## ADDENDUM NO. 1

Date: June 16, 2025  
Project: **Phase 1: Plant Utilities Relocation (Multipurpose Laboratory Building)**  
Job No.: 24600-01

**5 PIPE CONNECTION**  
NTS

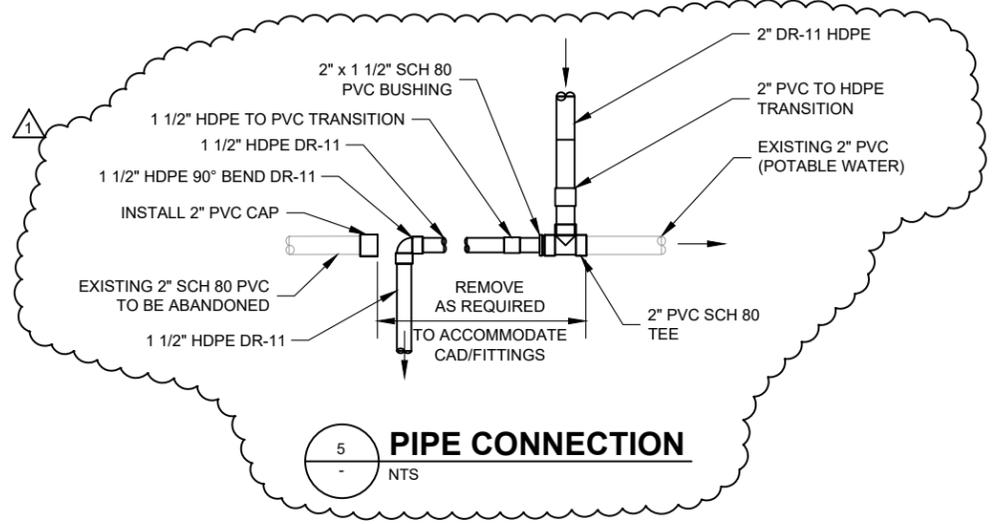
3. **Volume 4 – Drawings:**
  - a. **Sheet 01C901:** This sheet has been revised for Detail 5 and is included with this addendum.
  - b. **Sheet E201:** This sheet has been revised to reflect a new location of V21A that is outside of the roadway and is included with this addendum. Please note that this box represents both power and signal vaults.

**Response:** **RGXII is the correct part number.**
15. Q: Please clarify the termination of the 1 ½" HDPE line from the overflow shack shown below. Does the 1 1/2" HDPE PW line tee into the existing 2" PW line? This would change the extent of the planned demo and would leave the pipeline without a service connection. Or does it tee into the rerouted 2" HDPE PW line?

**Response:** **See revised Detail 5 on Sheet 01C901 included with this addendum.**
16. Q: Please confirm there are 4 new electrical pullboxes required.

NO.	DATE	DESCRIPTION	BY	APPR'D
1	06/12/2025	UPDATED PIPE CONNECTION #5	EES	JRL

**ELECTRICAL  
SITE PLAN**

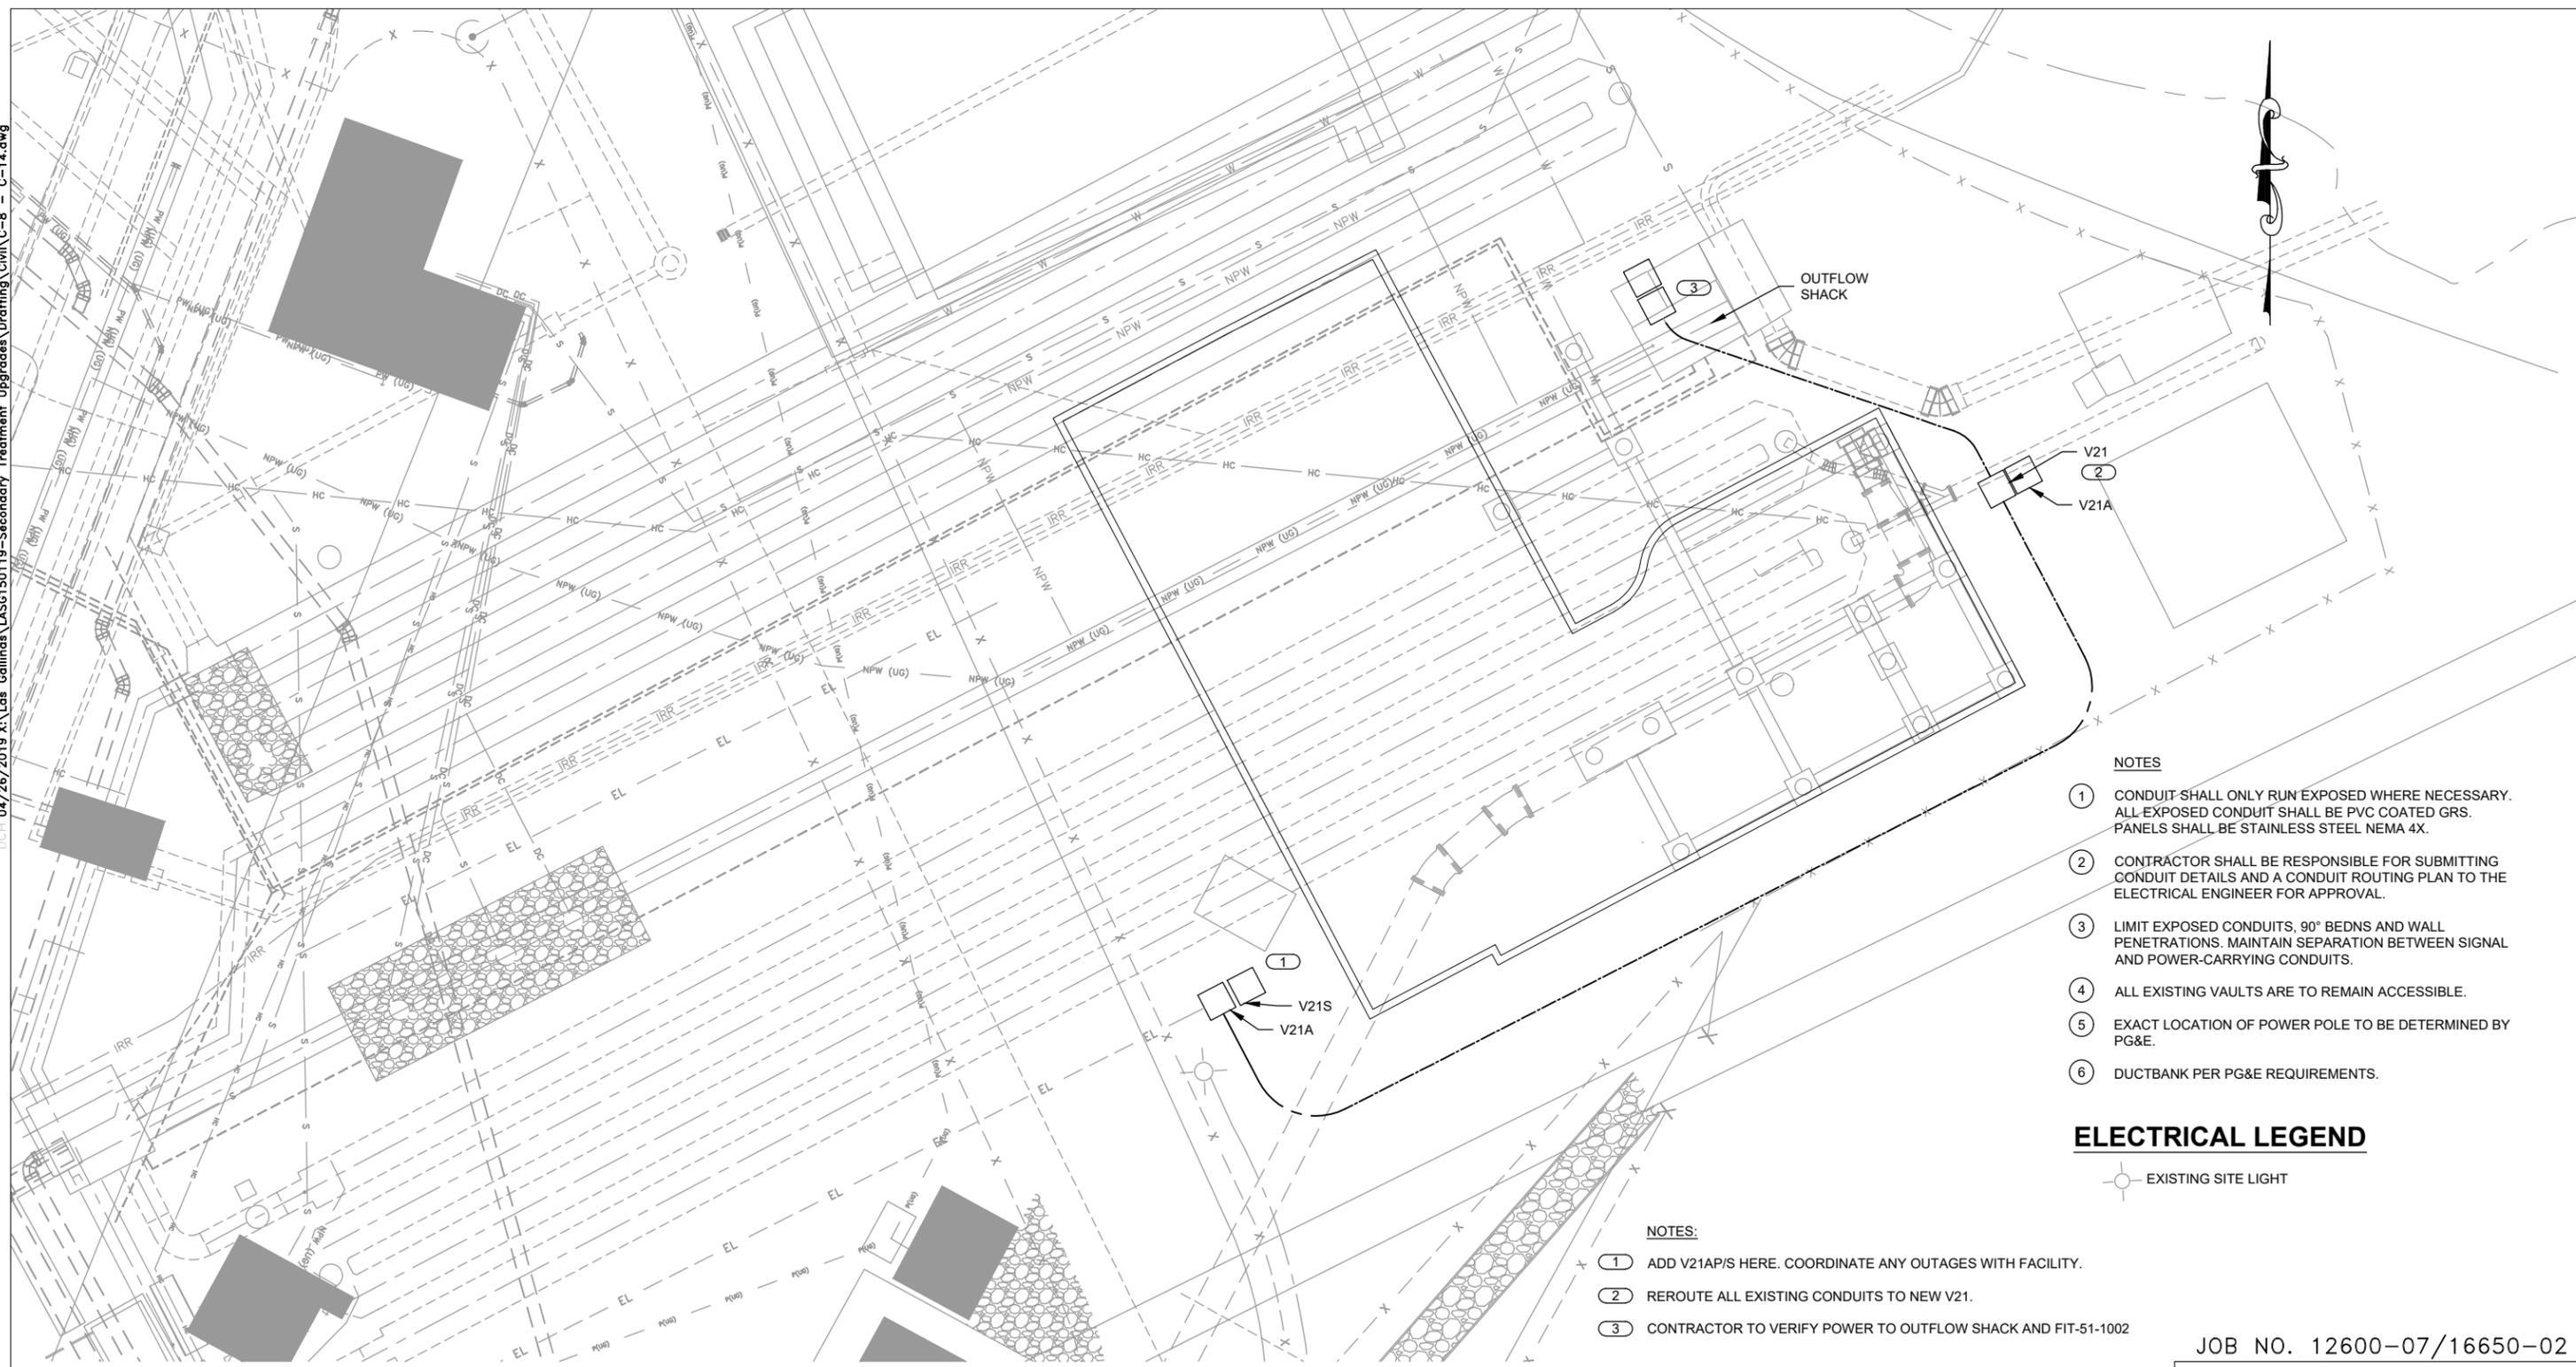
**Response:** **There is no new lighting. Drawing E201 has been updated to reflect this.**
19. Q: Drawing E601 - This drawing appears to show 4 pullboxes - V#21AP, V#21P, V#21S, V#21AS. These pullbox labels are not shown on Drawing E201 site plan. Please provide revised drawing showing these box labels on E201.

**Response:** **See revised Sheet E201 included with this addendum.**
20. Q: Please provide drawing showing locations of 51-G-1200, 41-G-2110, 41-G-2120, AIT 43-1340, and Outflow Shack LCP relative to V#21P and V#21S.

**Response: See revised Sheet E201 included with this addendum.**

- NOTES:**
- ① ADD V21AP/S HERE. COORDINATE ANY OUTAGES WITH FACILITY.
  - ② REROUTE ALL EXISTING CONDUITS TO NEW V21.
  - ③ CONTRACTOR TO VERIFY POWER TO OUTFLOW SHACK AND FIT-51-1002
